**Re: Comments on Ongoing Work to Satisfy the Red Hill Bulk Fuel Storage Facility
("Facility") Administrative Order on Consent ("AOC") Statement of Work
requirements 7.1.3 (Groundwater Flow Model Report) and 7.2.3 (Contaminant Fate
and Transport Report).**

Subject: Comments on the State of the Conceptual Site Model and Related Evaluations for the Navy Red Hill Tank Farm Facility, Pearl City, Hawai'i

Subject: Comments on Presentation Materials from the Red Hill Groundwater Modeling Working Group (GWMWG) Meeting #7 and Status of Interim Modeling as Presented Associated with Administrative Order on Consent ("AOC") Statement of Work Requirements 7.1.3 (Groundwater Flow Model Report) and 7.2.3 (Contaminant Fate and Transport Report)

RE: **Comments on the Progress of the Red Hill Groundwater Flow Model**

Figure 1. A comparison of the simulated and measured groundwater elevations in the RHMNW. RHMW07 is excluded from this graph since the water level in this well is very anomalous. The Red Hill Shaft (2254-01) is also excluded due to questions about the top of casing reference

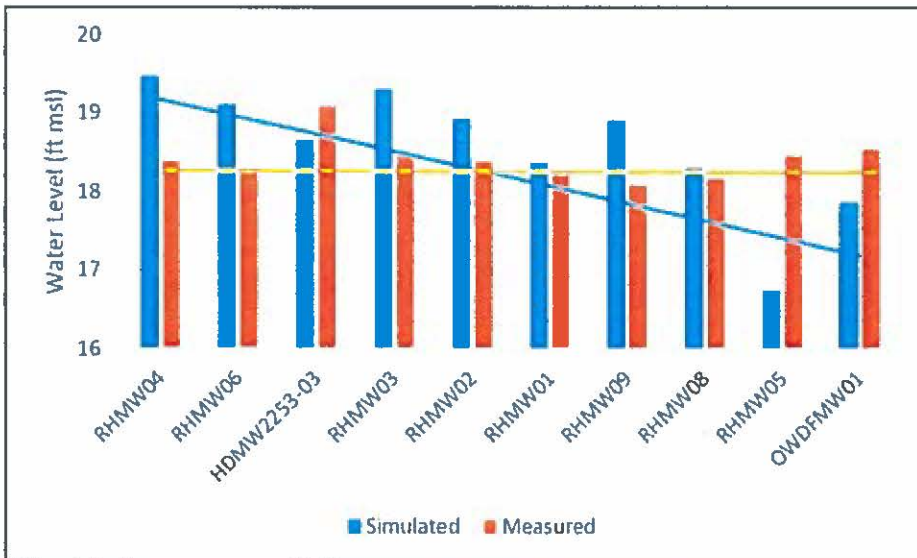
The model results presented in the February 12th Red Hill Groundwater Modeling Working Group (RHGWMWG) meeting show groundwater elevation patterns much different from those measured. For example Slide 24 from the February 12 RHGWMWG meetings shows that the simulated water level near RHMW05 is about a foot lower than that at RHMW02, much different than what is measured. In fact this infers a gradient of more than 3 feet per mile, rather than the flat gradient that is consistently measured. More importantly, for the Red Hill Shaft zone of contribution shown in Slide 57 to be valid the relative groundwater elevations simulated by the model within that zone of contribution should be in close agreement to those measured in the field.

The bar graph below compares the modeled groundwater elevations (blue bars) to those measured in 2017 (orange bars). The data are arranged going from RHMW04, the most upslope well, to OWDFMW01, the most down slope well. A visually estimated trend line is drawn for each data set. The values for the modeled groundwater elevations were derived by applying the modeled residuals in Slide 30 to the average of water level measurements during the July and November rounds of groundwater sampling. For the modeled capture zone shown on Slide 57 to be valid there should reasonable agreement between the trend in the modeled and measured groundwater elevations. Clearly this is not the case, and the presented model is essentially no better than that of Rotzoll and El-Kadi the Red Hill investigation is tasked to improve upon.

In summary, for the groundwater flow model to be acceptable as a risk assessment tool, there must be much better agreement between the simulated and measured water levels in the critical areas. These areas are the Moanalua area wells, the RHMNW wells, and the wells in the Halawa area.
